**FINDINGS OF FACT  
FLORENCE COMMUNITY DEVELOPMENT DEPARTMENT  
Exhibit "A"**

**Application:** PC 20 15 CUP 04 – Conditional Use Permit with Design Review

**Proposal:** Operation of a "La Mota" recreational marijuana dispensary in an existing structure, most recently permitted for retail sales use.

**Location:** 470 Hwy 101, Florence  
Map # 18-12-27-44, Tax Lot 11800

**Exhibit C**

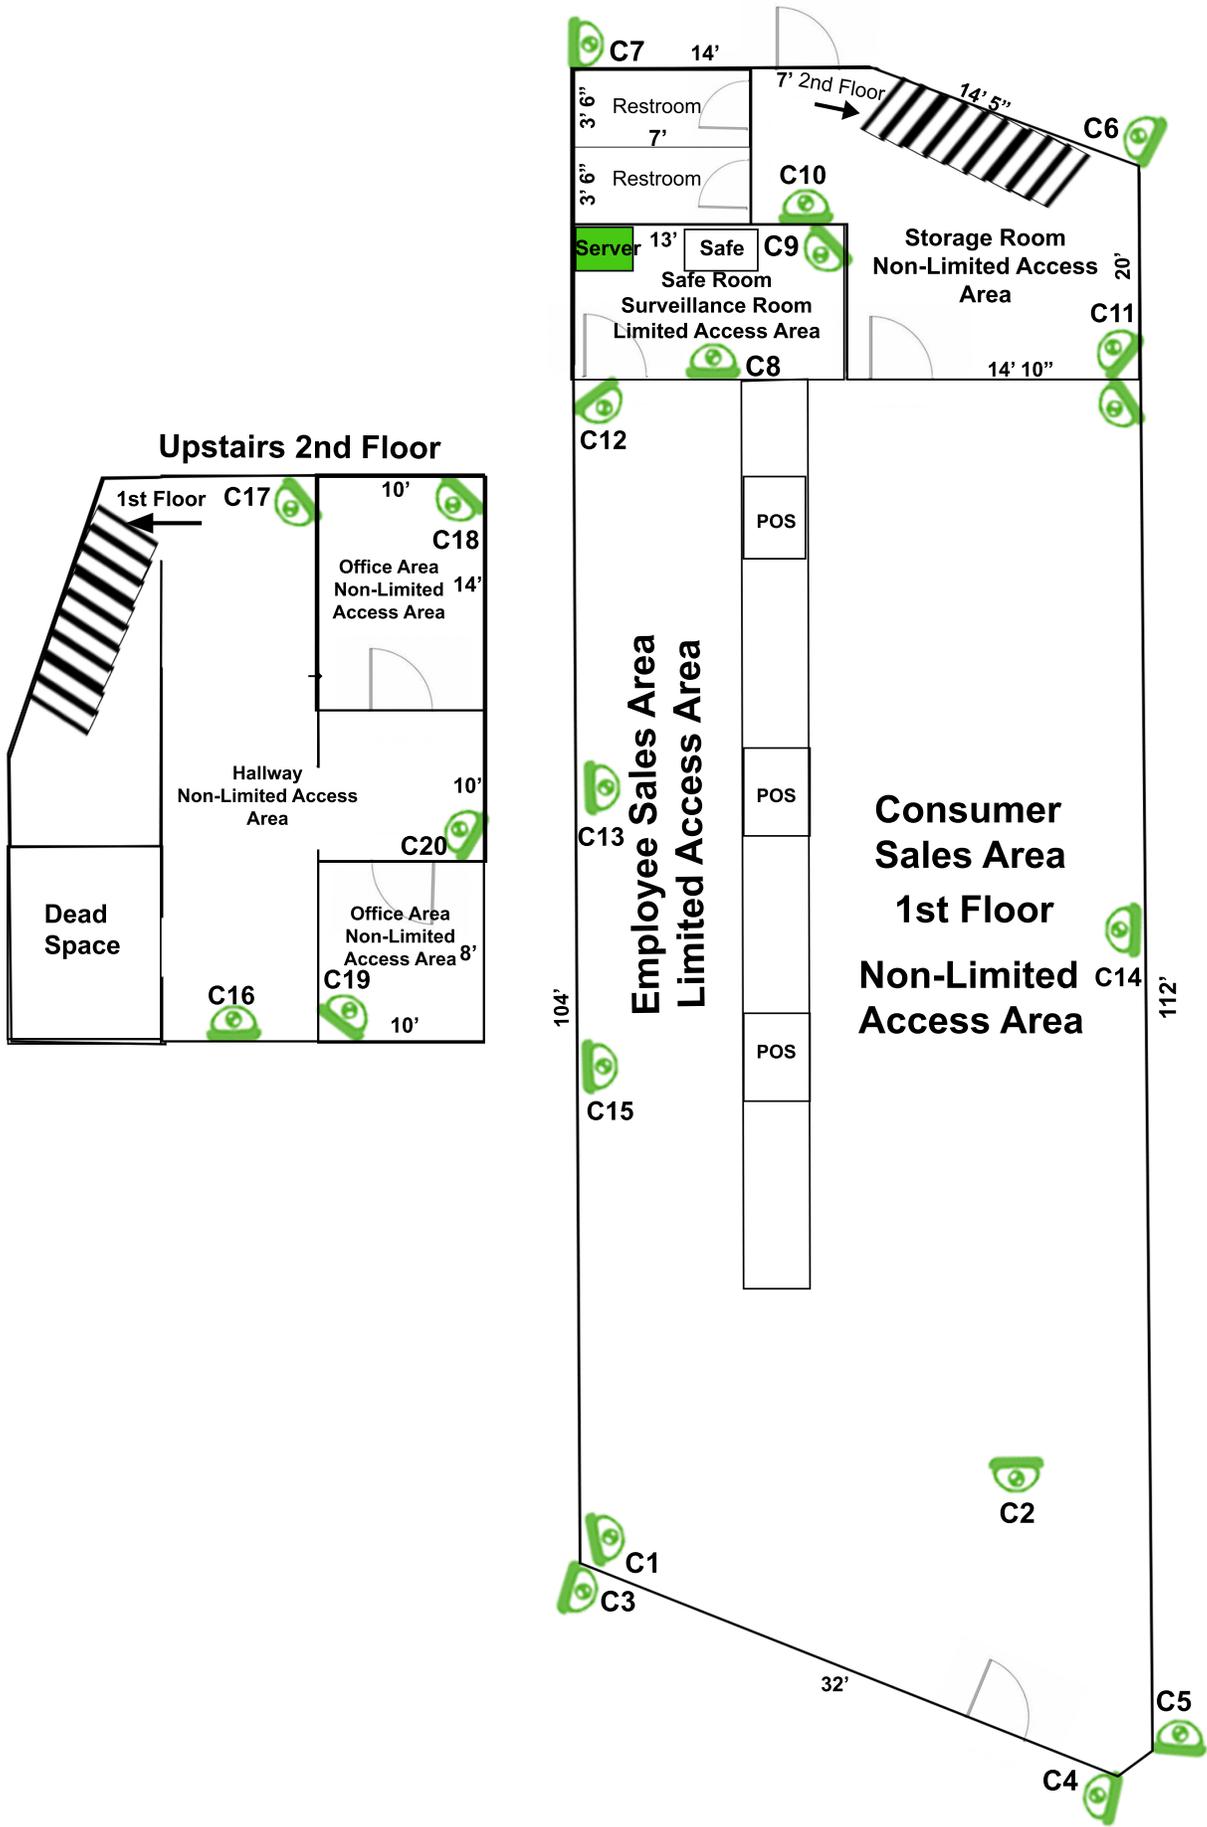
Per Table 10-3-1- Minimum Required Parking by Use, the applicant is required to have 1 space per 333 square feet building space (exterior footprint). The existing building pad, as shown in Exhibit C Site Plan, is approximately 5,355 square feet, requiring 16 spaces (one of which must be ADA, per Table 10-3-2 below). The lot currently has 3 spaces, none of which are ADA-marked.

The existing 3 parking stalls meet the dimensional requirements of 10-3-9, above, for a one-way drive aisle. (The three spaces are oriented at a 60-degree angle, and are 9'5" by 18.5". See Exhibit C Site Plan.)

Note that this finding is based on a one-way drive aisle. The aisle is signed one-way at its exit on 101, but is not currently signed one-way on its entrance off Rhododendron. This is discussed in detail in the findings in this report related to 10-35 Access and Circulation.

Condition 10: The applicant shall submit a parking plan, meeting the standards of FCC 10-3 Parking & Loading, including but not limited to providing 8 parking spaces one of which shall be an ADA space, sized and striped in accordance with code, and bicycle parking.

11. The parking stalls on Subject Property shall be re-striped, and meet the requirements of 10-3-9 Parking Stall Design and Minimum Dimensions.
12. The applicant shall submit a site circulation plan, meeting the requirements of 10-35 Access and Circulation.
